MEMORANDUM

Project No.: 24-0388

EPC Project Number: PPR2315

Business Park 2- Drainage Compliance Letter

C5.1

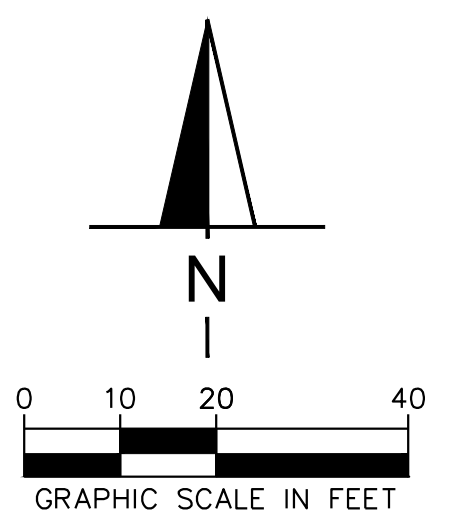
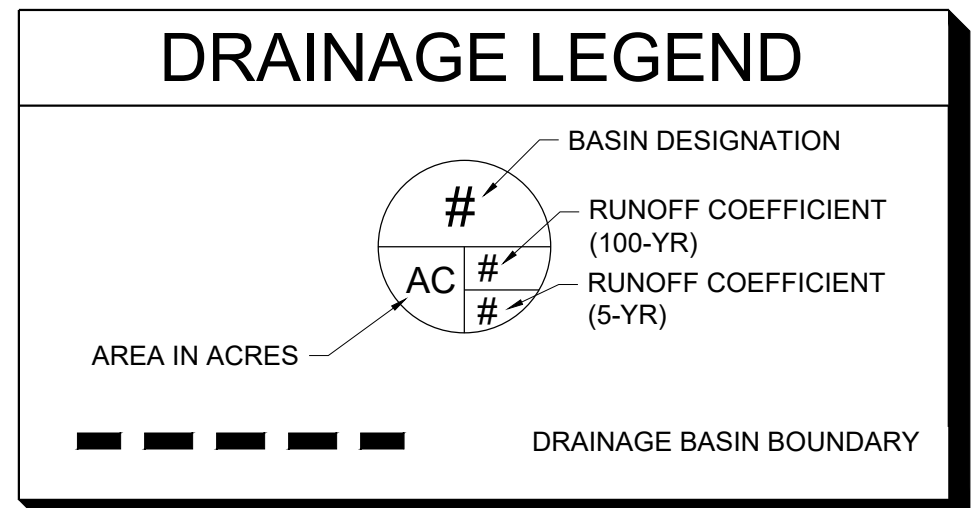
Per the final drainage report of the original subdivision (PCD File SF2014) and per the report submitted with the vacate replat (VR233) site runoff is not intended to drain to meadowbrook parkway. If proposing to drainage to Meadowbrook, analysis of total flow including this developments flow within meadowbrook parkway shall be provided as well as the ultimate outfall fro flow within meadowbrook.

Please also address the stormwater engineers comment regarding water quality for this area as 100% of the site shall be treated per ECM appendix I.

How will the runoff from OFF1 be treated? If you will use exclusions for this basin, clearly state in the PBMP form and the Drainage Letter text.

Please label all storm facilities

Provide in the text of your report a narrative description of the proposed sub-basins. Identify the appropriate design points as well.

Label all storm drains and provide flow arrows to all watersheds to clearly show drainage patterns.

please provide the drainage plan as the last page of the report.

account for offsite flow entering the site

Where does the runoff in the highlighted section go? It appears to collect on the back of the proposed curb. If this never combines with the rest of A2 this should be its own basin and will need to have WQ accounted for.

CDS4040-8-C - 744893-10
SUPERSTAR CARWASH
COLORADO SPRINGS, CO
for SYSTEM: CONTECH CDS
HYDRODYNAMIC SEPARATOR

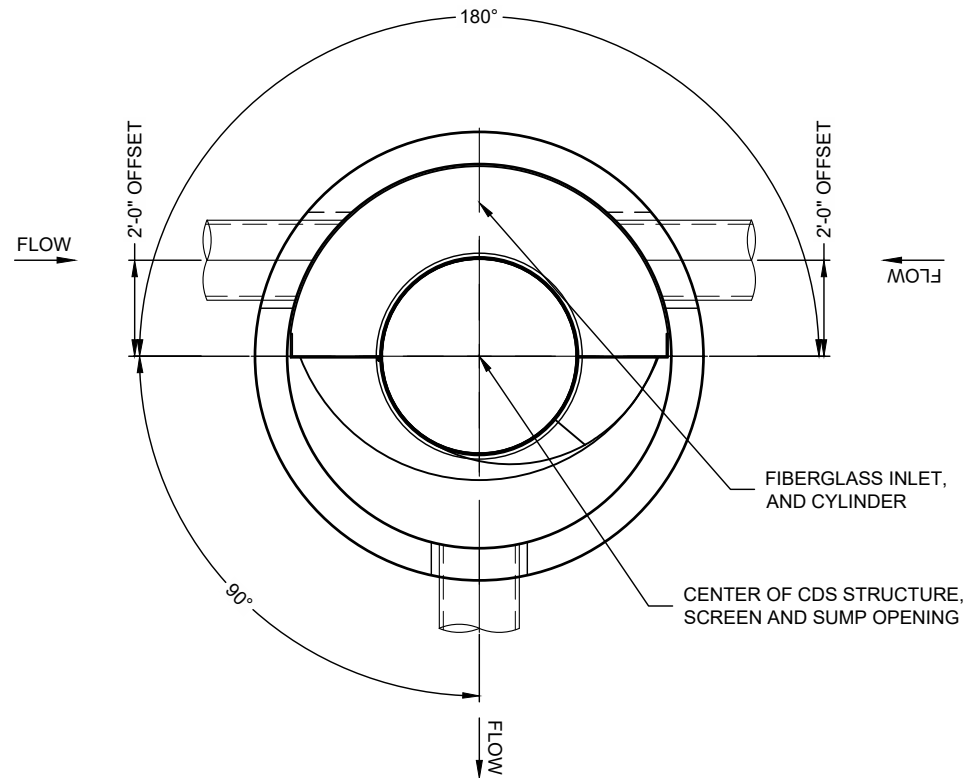
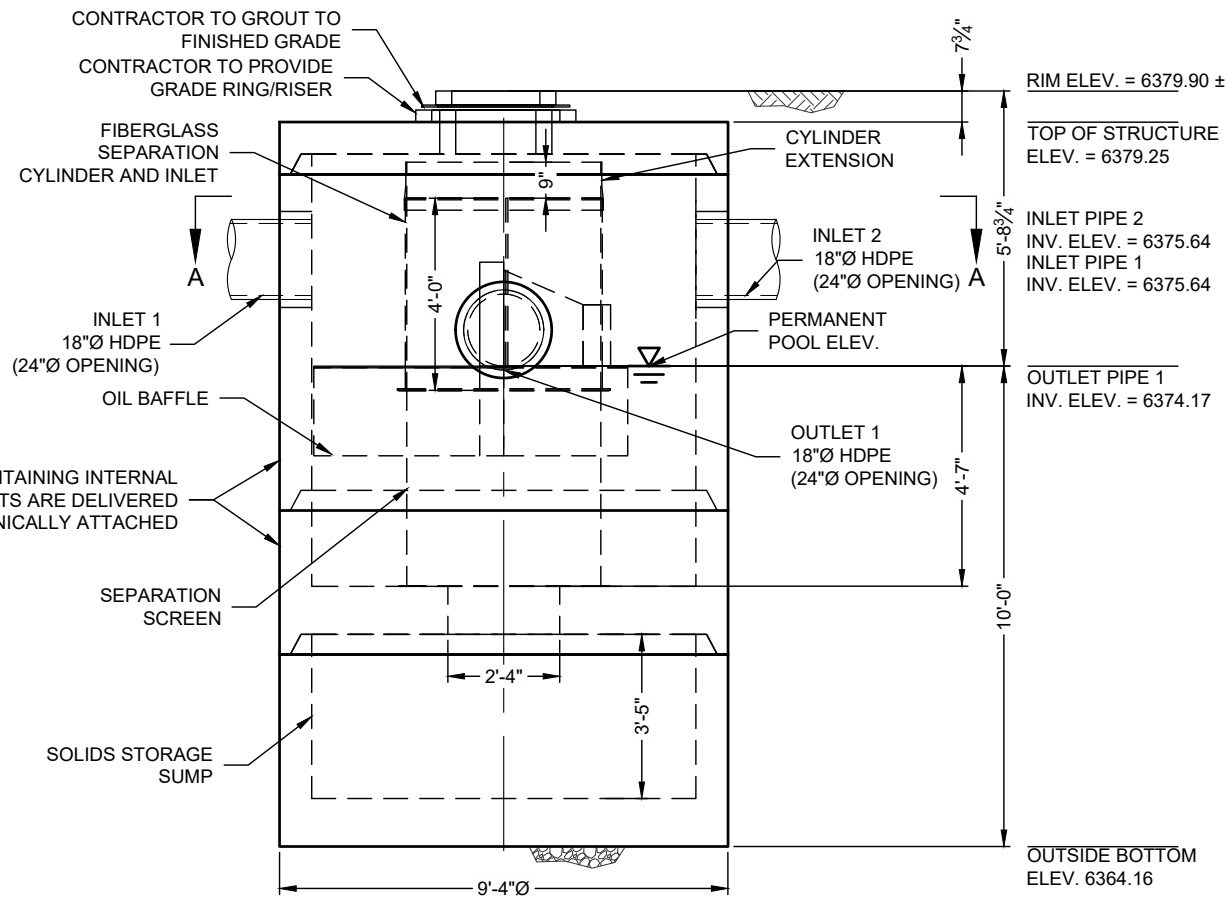
Underground WQ treatment will need to be approved, applicant must submit a deviation request explaining why above ground is not feasible.
